**SUBJECT: GEOTECHNICAL RECONNAISSANCE**  
Residential Property Development  
Snohomish County Parcel No. 00408600400  
100XX 63<sup>rd</sup> Place West  
Mukilteo, Washington  
Project No. 17-114-01

Subject:     **ADDENDUM LETTER**  
Proposed New Residence  
6300 Webster Way  
Mukilteo, Washington 98275

PROPOSED NEW RESIDENCE  
6300 WEBSTER WAY  
MUKILTEO, WASHINGTON

**Subject: ADDENDUM LETTER 2**  
Proposed New Residence  
6300 Webster Way  
Mukilteo, Washington 98275

Plate 1 – Site Plan

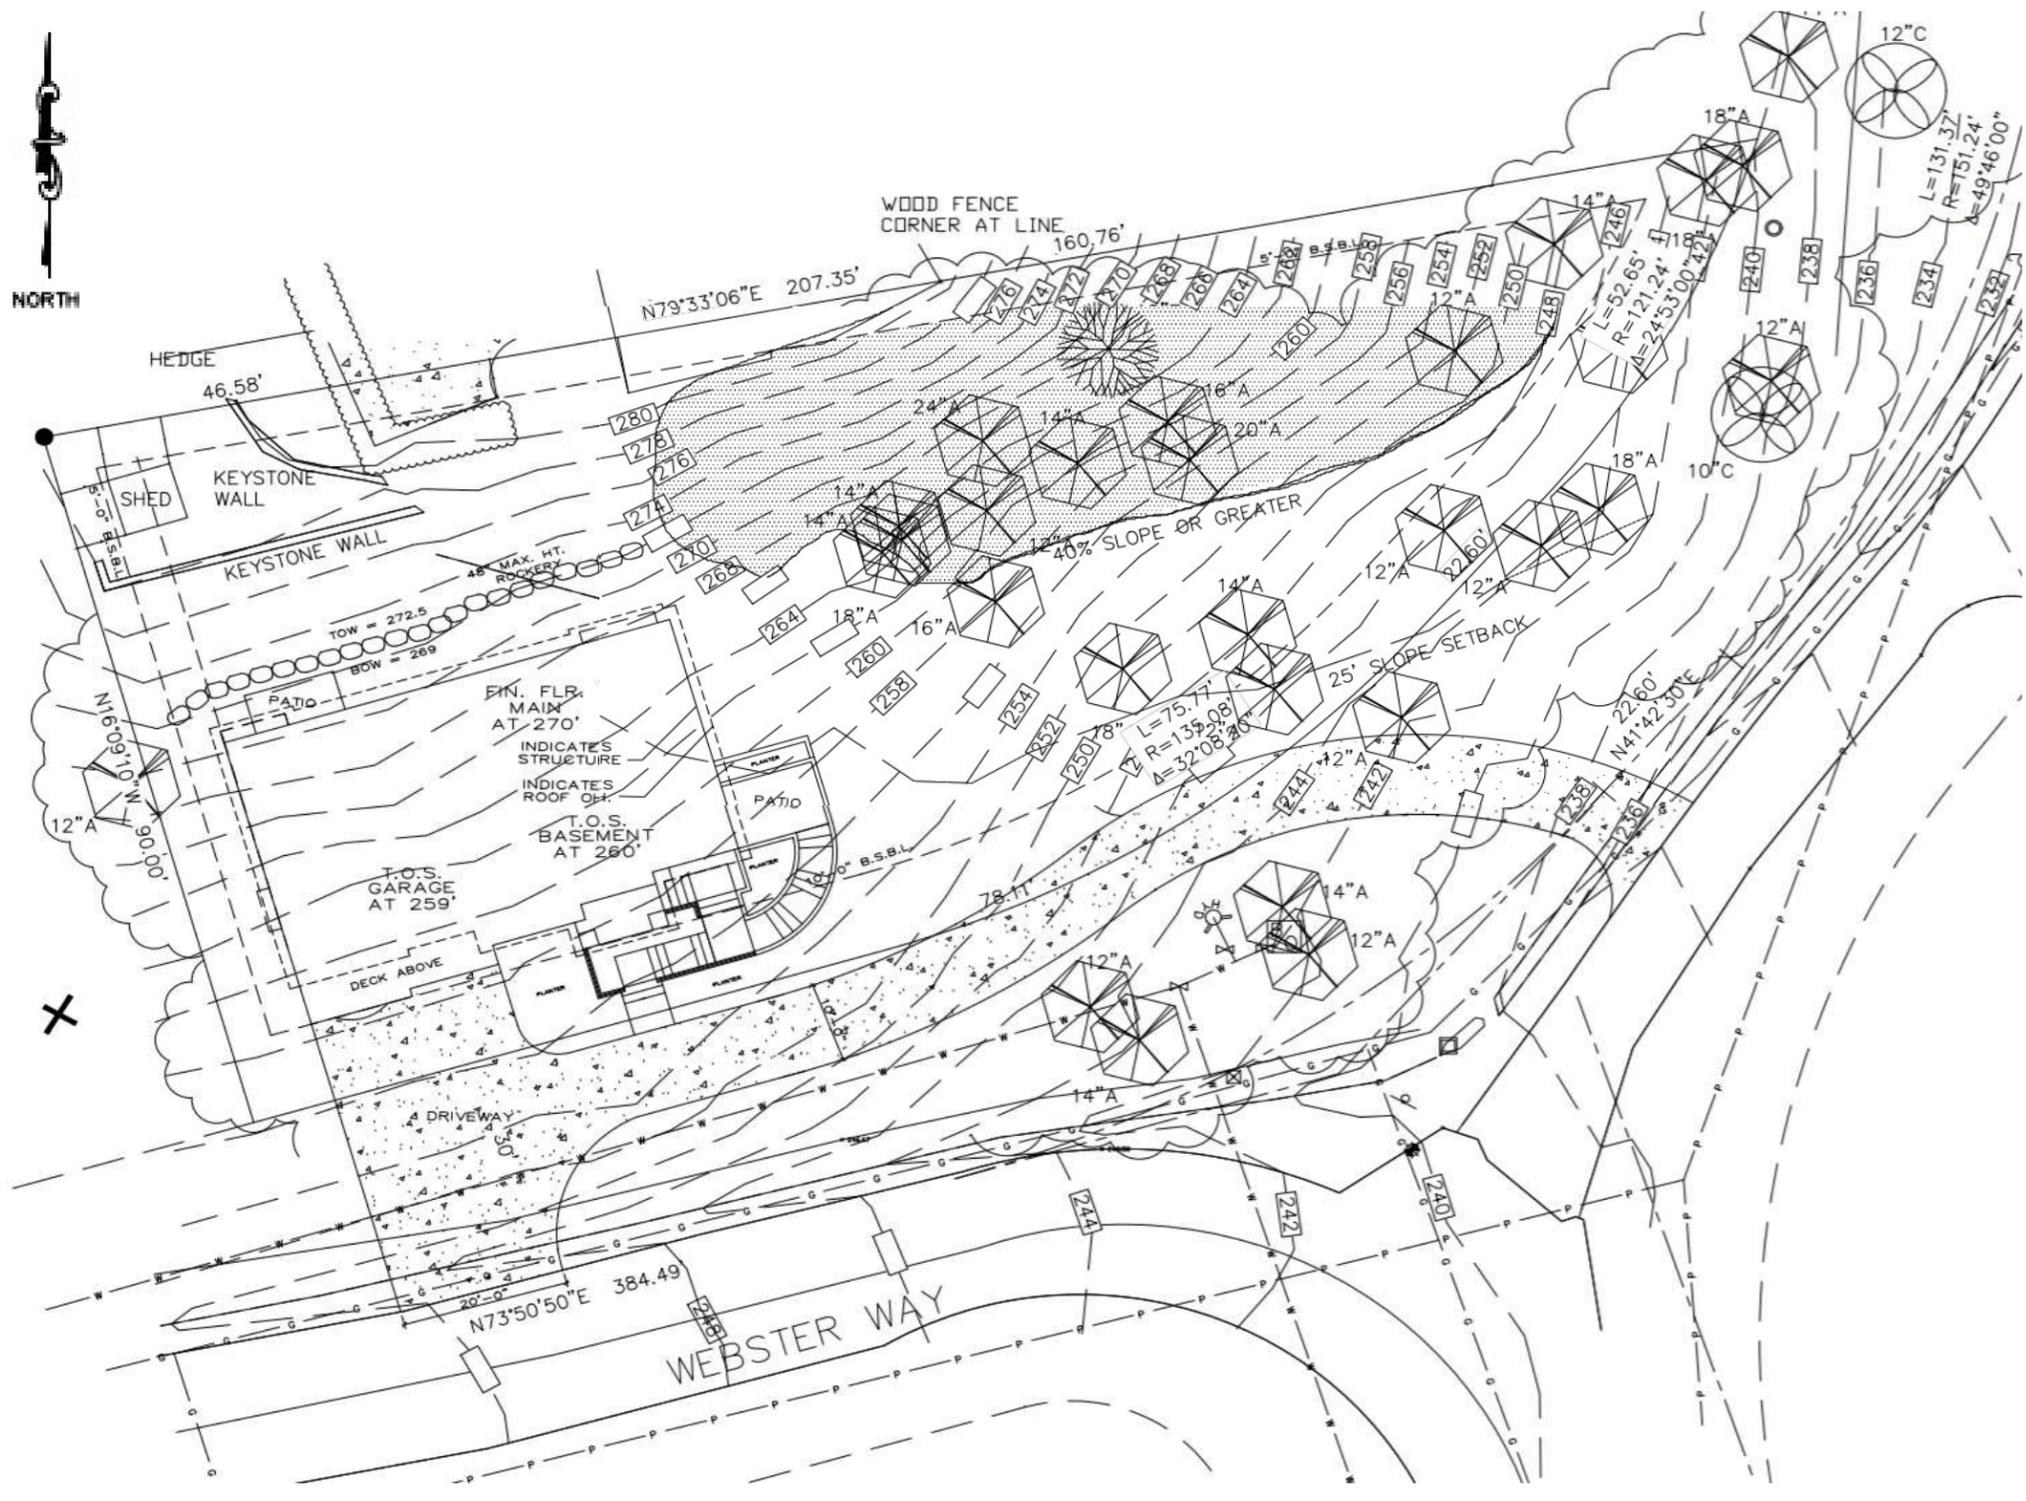
Based on the information provided, we understand that you are proposing to develop the west section of the existing vacant lot with the construction of a new two-story single-family residence with a south-facing daylight basement and attached garage. The garage will be accessible by a driveway that begins east of the intersection of Webster Way and 63<sup>rd</sup> Place W and runs parallel to the south property line towards the residence along gradually sloped topography. The residence will have a footprint of approximately 1700 square feet, with a total interior living space of 4,000 square feet within the three floors. We understand that excavations into the existing slope at the west section of the property will be required for the construction of the new residence, but this section of the property is not mapped as a steep slope. As noted in the above-referenced geotechnical report, the site contains steep to very steep slopes within the central and northeast areas and therefore is considered a Geologic Sensitive Area. The existing steep slope and the footprint of the proposed residence are illustrated in in Plate 1 – Site Plan.

The above-referenced geotechnical report mentions that a slope stability analysis was conducted for the steep slope areas in the central and northeast sections of the property. The analysis found that the property has safety factors for deep-seated slope failures greater than 1.5 for the static condition and 1.2 for the seismic condition, indicating that the property is stable in its existing condition. The geotechnical engineer recommended that the proposed residence's setback from the steep slope could be reduced from 25 feet due to the nature of the boundary between the moderate and steep slope areas because the boundary is lateral and not above or below the steep slope.

The geotechnical report concluded that site disturbance for the new residence is acceptable up to the edge of the steep slope area, but that a setback distance of 10 feet from the slope should be implemented regardless. The project plans indicate that the proposed footprint of the residence will be located no less than 10 feet from the edge of the steep slope, and that the driveway area will be located more than 25 feet away from the bottom of the steep slope. It is our opinion that the reduced setback will not cause any adverse impacts to the steep slope area at the central and northeast sections of the property.

Based on the site conditions observed and our review of the project plans, it is our opinion that the recommendations outlined in the above-referenced geotechnical report have been properly implemented into the design of the proposed new single-family residence. The plans show that the residence will be located at the west section of the property where the topography does not contain any critical slopes with inclinations greater than 40%, and that site development will not occur within a setback distance of 10 feet from the western edge of the steep slope. In our opinion, these plans will not adversely impact the steep slope or the adjacent properties to the north and west.

Plate 1 – Site Plan

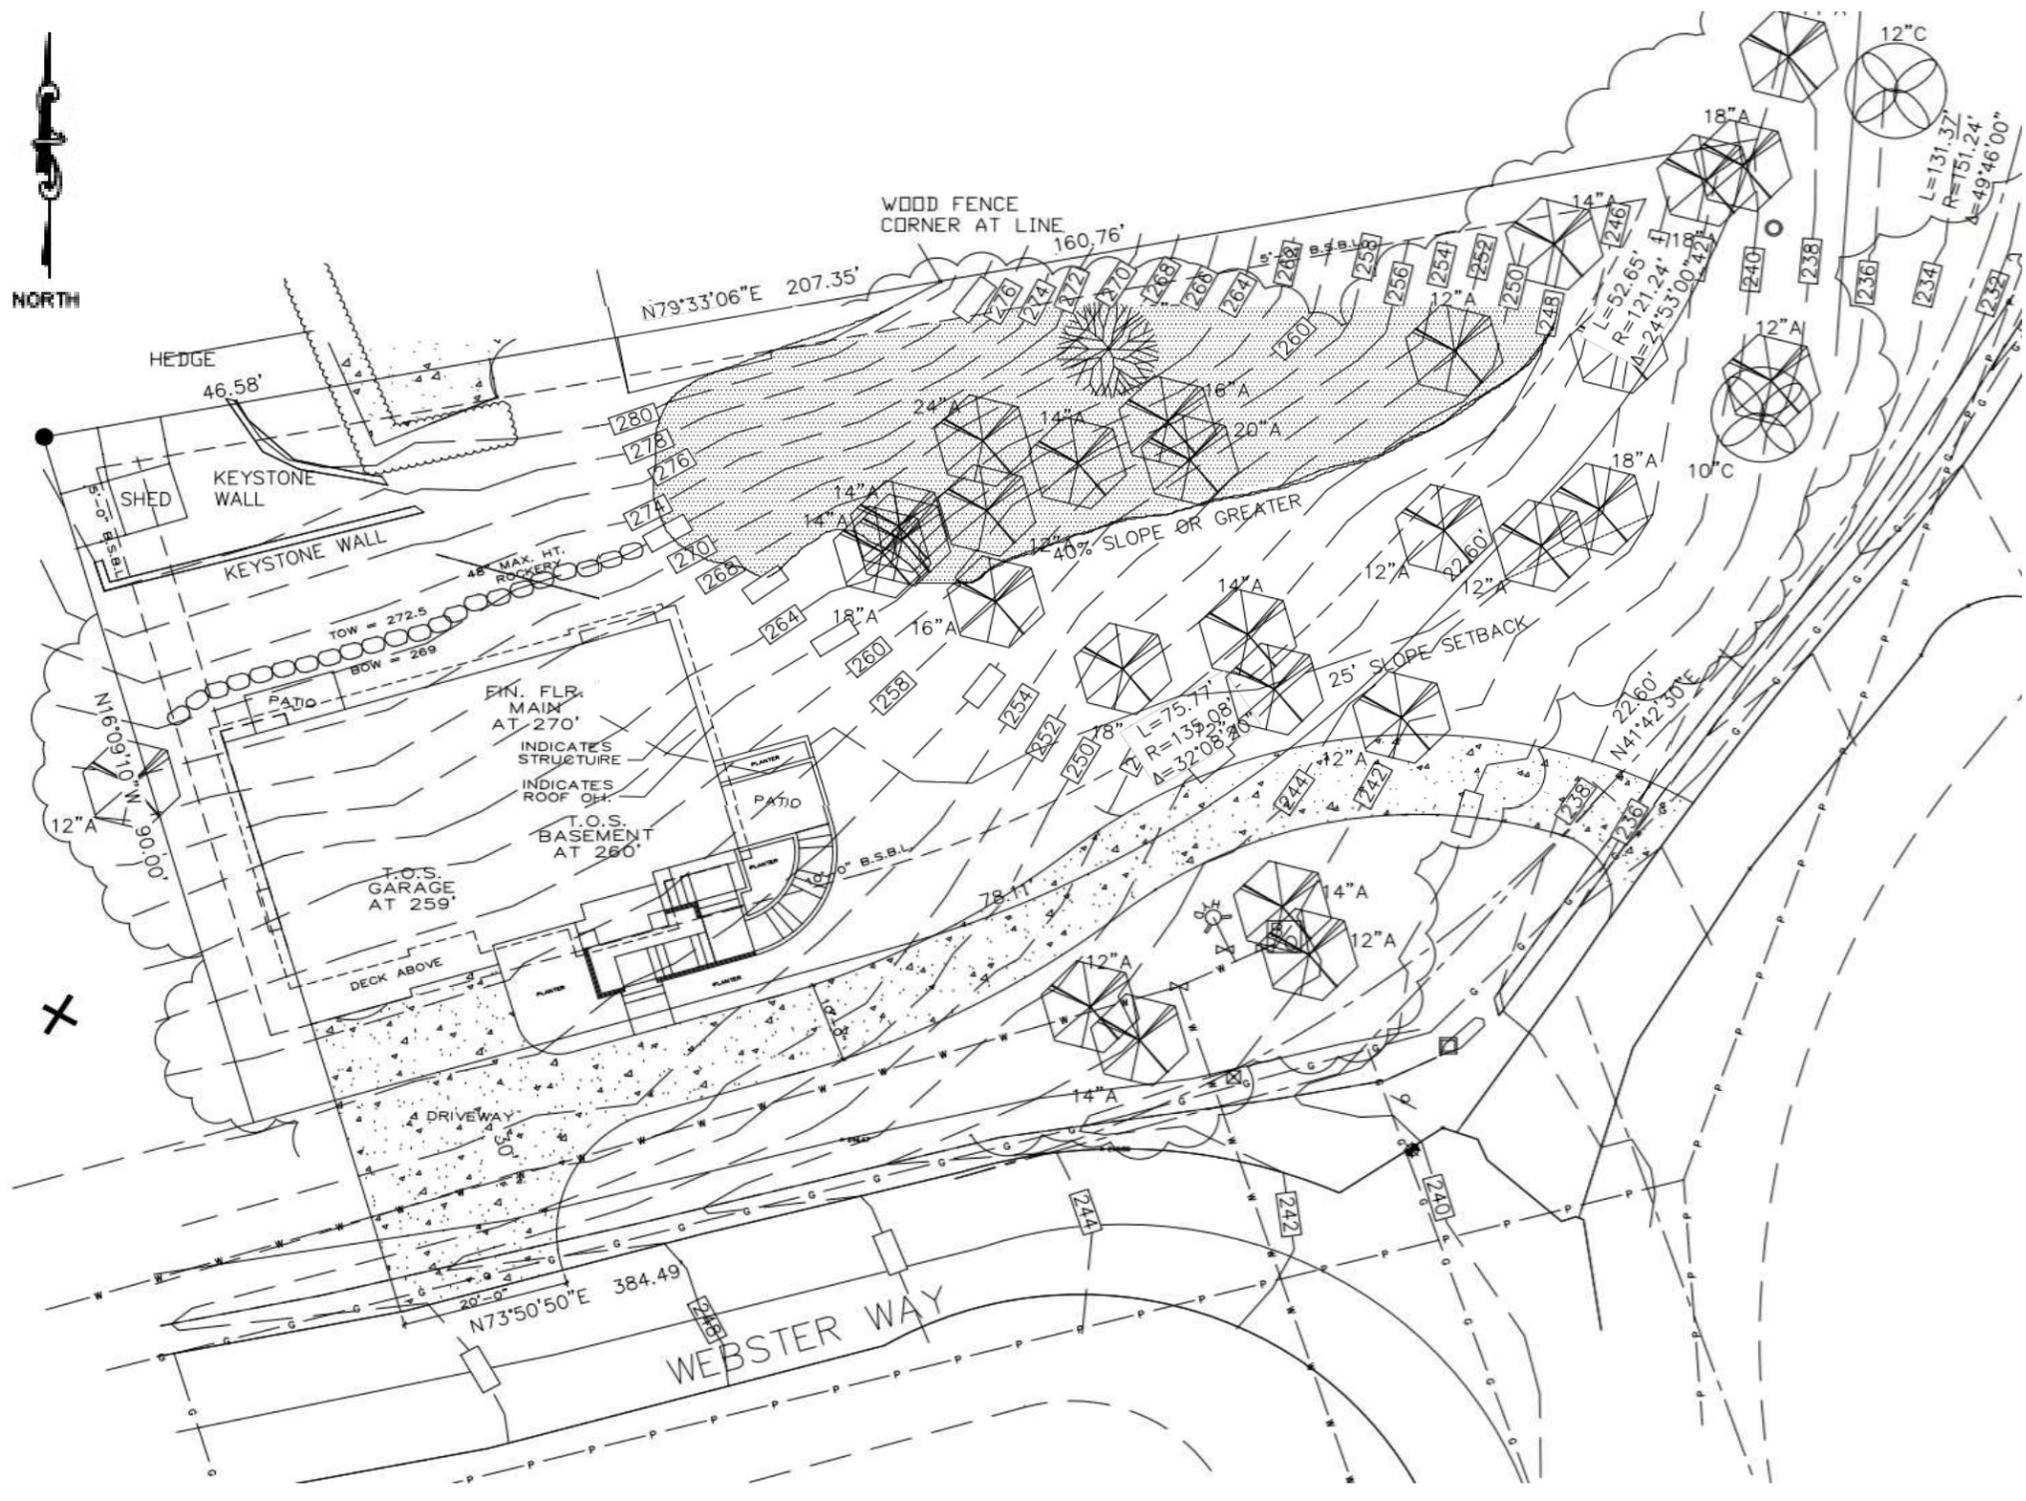
Based on the information provided, we understand that you are proposing to develop the west section of the existing vacant lot with the construction of a new two-story single-family residence with a south-facing daylight basement and attached garage. The garage will be accessible by a driveway that begins east of the intersection of Webster Way and 63<sup>rd</sup> Place W and runs parallel to the south property line towards the residence along gradually sloped topography. The residence will have a footprint of approximately 1,857 square feet, with a total interior living space of 4,000 square feet within the three floors. We understand that excavations into the existing slope at the west section of the property will be required for the construction of the new residence, but this section of the property is not mapped as a steep slope. As noted in the above-referenced geotechnical report, the site contains steep to very steep slopes within the central and northeast areas and therefore is considered a Geologic Sensitive Area. The existing steep slope and the footprint of the proposed residence are illustrated in in Plate 1 – Site Plan.

The above-referenced geotechnical report mentions that a slope stability analysis was conducted for the steep slope areas in the central and northeast sections of the property. The analysis found that the property has safety factors for deep-seated slope failures greater than 1.5 for the static condition and 1.2 for the seismic condition, indicating that the property is stable in its existing condition. The geotechnical engineer recommended that the proposed residence's setback from the steep slope could be reduced from 25 feet due to the nature of the boundary between the moderate and steep slope areas because the boundary is lateral and not above or below the steep slope.

The geotechnical report concluded that site disturbance for the new residence is acceptable up to the edge of the steep slope area, but that a setback distance of 10 feet from the slope should be implemented regardless. The project plans indicate that the proposed footprint of the residence will be located no less than 10 feet from the edge of the steep slope, and that the driveway area will be located more than 25 feet away from the bottom of the steep slope. It is our opinion that the reduced setback will not cause any adverse impacts to the steep slope area at the central and northeast sections of the property.

Based on the site conditions observed and our review of the project plans, it is our opinion that the recommendations outlined in the above-referenced geotechnical report have been properly implemented into the design of the proposed new single-family residence. The plans show that the residence will be located at the west section of the property where the topography does not contain any critical slopes with inclinations greater than 40%, and that site development will not occur within a setback distance of 10 feet from the western edge of the steep slope. In our opinion, these plans will not adversely impact the steep slope or the adjacent properties to the north and west.
